Citizens' Oversight Projects (COPs)

August 24, 2012

**QUESTIONS FROM CITIZENS OVERSIGHT PROJECTS
(COPS) REGARDING STEAM GENERATOR TUBE
FAILURES AT SAN ONOFRE NUCLEAR GENERATING
STATION**

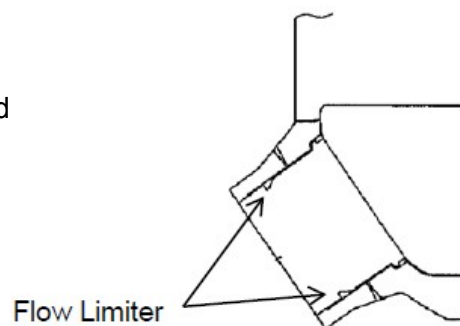
Additionally, Mitsubishi identified that the Unit 3 replacement steam generators had **better dimensional controls during the fabrication process**. This determination was based, in part, on the results of pre-service and in-service eddy current examinations, and fabrication data from Unit 2 and Unit 3 replacement steam generators. The correlation of dimensional controls with the failure mechanism was that improved dimensional controls for Unit 3 replacement steam generators resulted in less variability of as-built critical dimensions such as anti-vibration bar thickness, tube roundness, and gaps between tubes and anti-vibration bars.

It is always assumed that better dimensional control means that the system will perform better. But in terms of fluid-elastic instability, **having tubes with exactly the same natural frequency** will mean that the whole thing will start to vibrate like mad at one key frequency, whereas poor dimensional controls may result in natural frequencies of vibration that are not exactly the same, and thus individual tubes might vibrate, but the additive effect of having many tubes with the same natural frequency may make it **MORE subject to fluid-elastic instability rather than the other way around**.

Q23 ---> Did the team consider that better dimensional control may lead to vibrations that reinforce each other and result in a unstable pole that may lead to catastrophic failure?
